## Product Change Notice (PCN)

**Subject:** Change of Final Test, Visual Inspection and Packing site for RH850 Series assembled at Yonezawa factory

**Publication Date:** 8/29/2025

**Label Example: RH850/F1 Series R7F7017154ABG-C (#BC1: Tray, #HC1: T&R)**

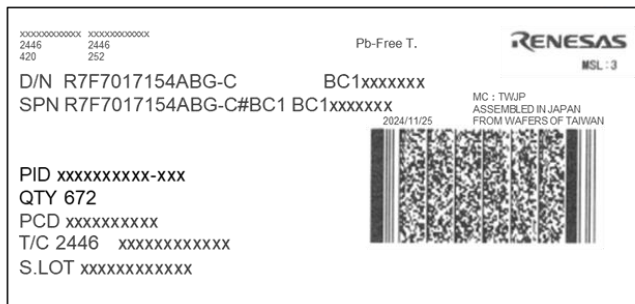
**[Current] WP : TSMC, Assy : Yonezawa, FT : Yonezawa (Tray)**

**Packing Specification**

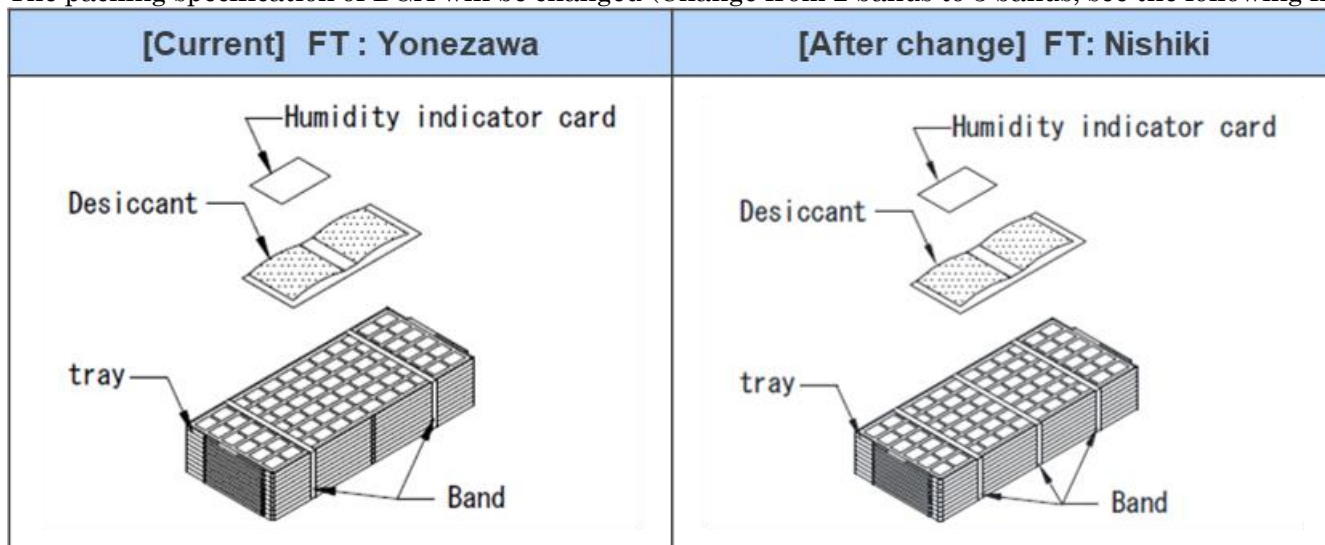
The packing specification of BGA will be changed (Change from 2 bands to 3 bands, see the following figures).
